From: Marc McGinnis <marcm@geotechnw.com>
Sent: Friday, December 9, 2022 8:27 AM
To: Caleb Slater
Cc: Brady Berriman; Bree Medley; Dave Delendeck
Subject: [REDACTED] (Permit #2202-257)

The City had a couple comments regarding the trench/ swale below the building roof overhang and I wanted to follow up with you. Please see below for what we're thinking for the coarse soil trench

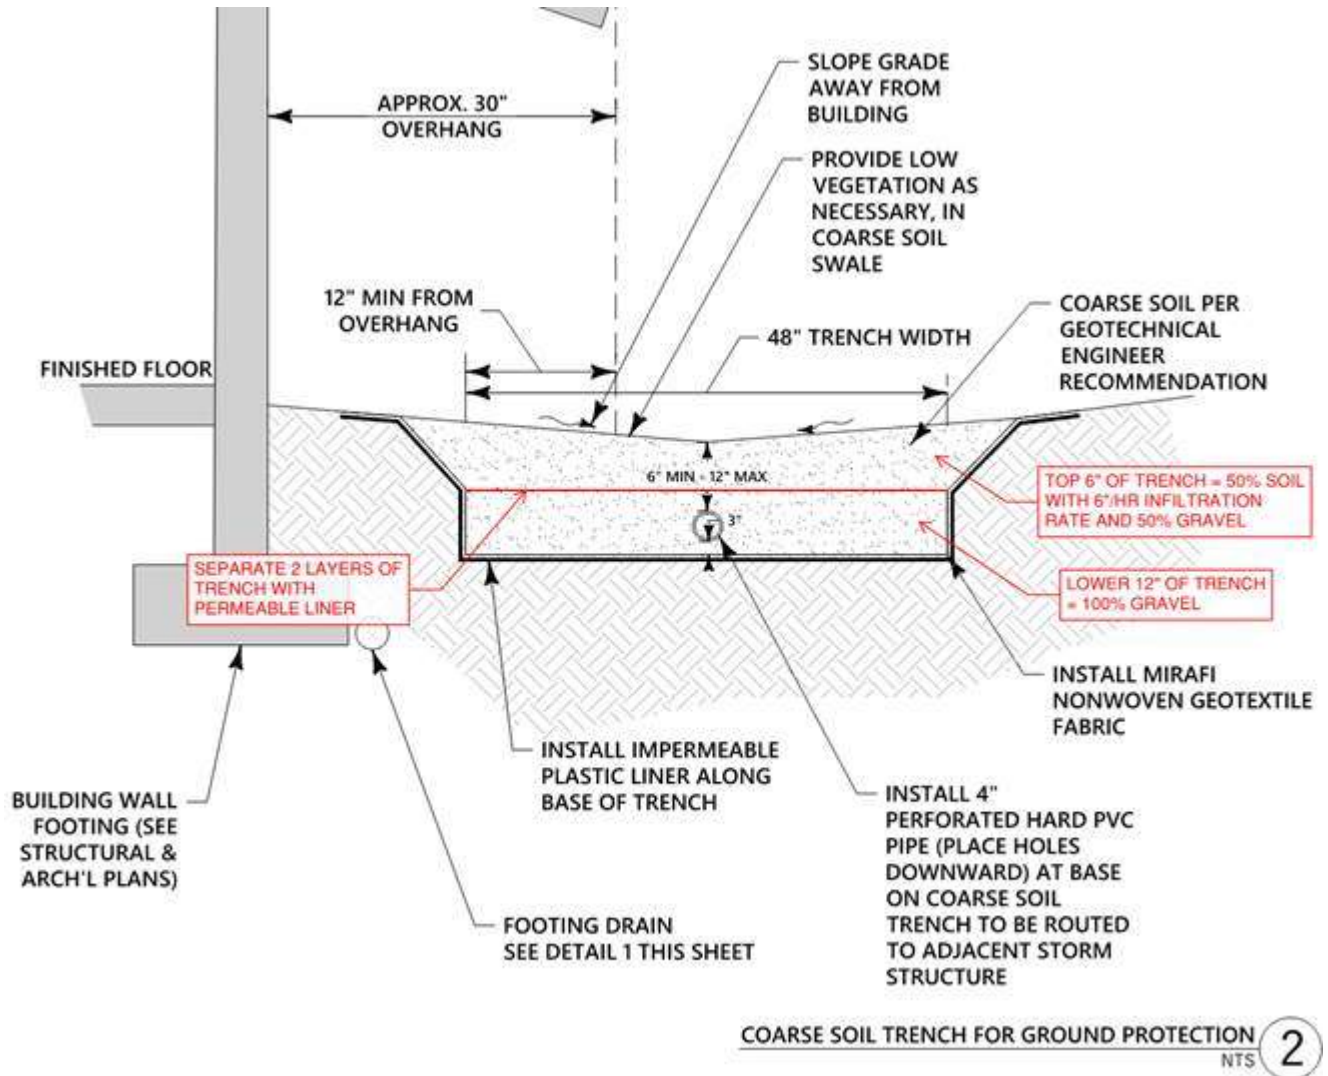
section. The top 6" is to be 50% gravel and 50% soil with a hydraulic conductivity of 6"/hr minimum. The lower section of the trench will be 100% gravel, with the two layers separated by a permeable liner. Can you weigh in on the following?

- Recommended type(s) of coarse soil to be used in trench with a minimum hydraulic conductivity of 6"/hr?
- Recommended non-erosive plants to be in the trench for natural dispersion of runoff?

For the coarse soil, I recommend the following gradation. This will be a coarse-grained soil that will easily achieve more than 6"/hour of infiltration capacity.

Seive Size	Percent Passing
4"	99-100
3"	75-100
U.S. No. 4	50-75
U.S. No. 40	30 max.
U.S. No. 200	5 max.

I am not much of a plant person. These soils will be so well-drained that something very drought tolerant and hardy will be needed. I suspect some type of grass, such as used in BioPlanters, but am not sure. I hope that the landscape architect can help with this.
